Drawn to ISO STANDARDS Tolerancing ISO 8015	General tolerances ISO 2768-mK		Unless Stated Otherwise Units LENGTH: mm ANGLE: DEG		Scale 2:5
	Material SEE NOTES			Treatment SEE NOTES	
Created by		Approved by		Document type MECH OUTLINE	
Dept. CNH		Technical reference N/A		Document status N/A	
Title, Supplementary title MECHANICAL OUTLINE,					
Rev. AB	Date of issue 2014-10-03	Lang. EN	Sheet 1 of 1

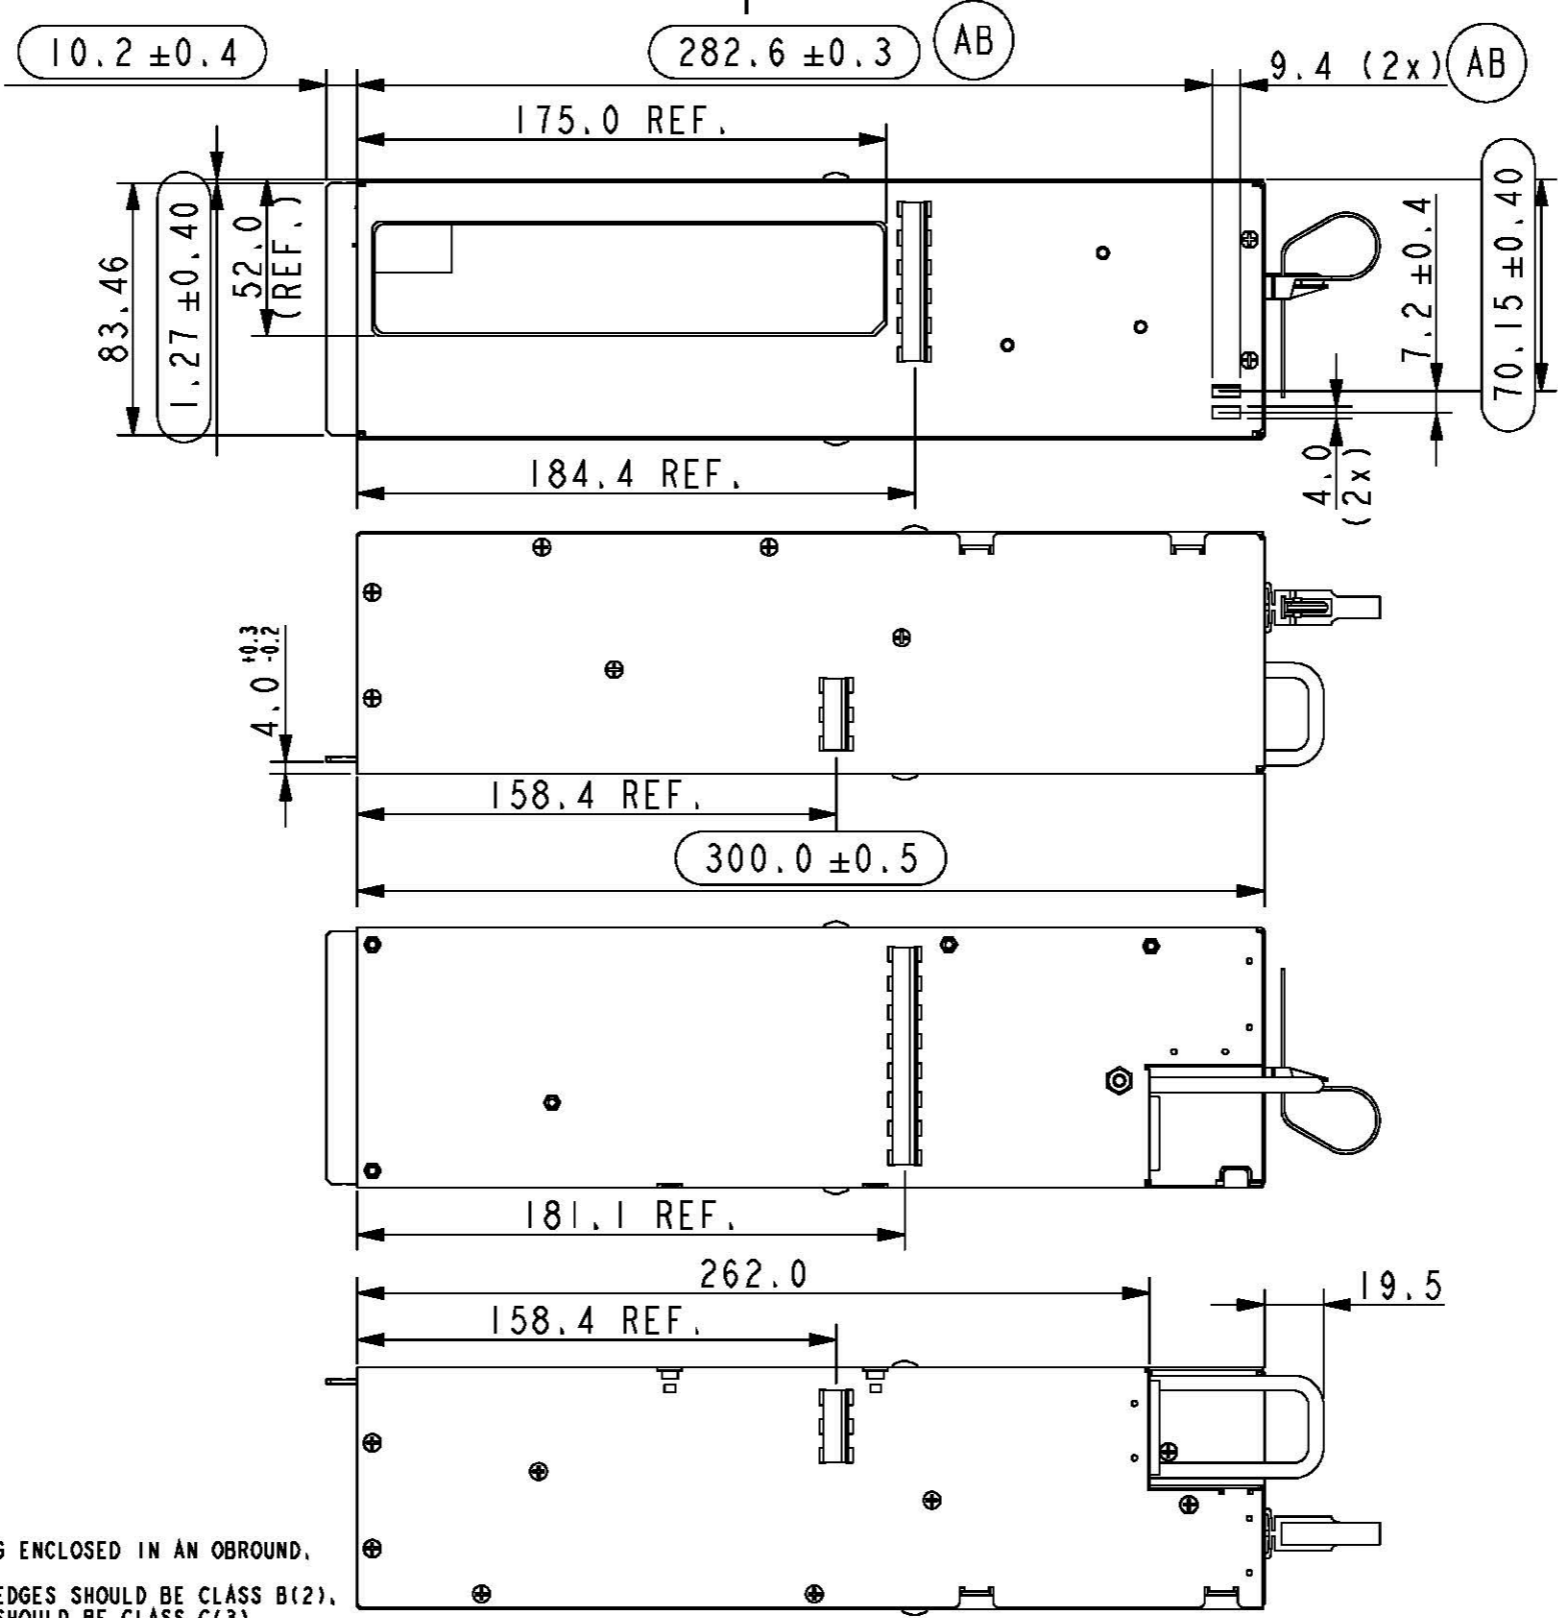
P/N SUFFIX	REVISION	ECO NO.	REVISION DESCRIPTION	DATE	REVISED BY	APPROVED BY
-0000	AB		DIM. 282.6±0.3 WAS 282.0±0.4. DIM. 9.4 (2x) WAS 10.0 (2x).	2014-10-03		
-0000	AA			2014-09-03		
SHEET REVISION HISTORY
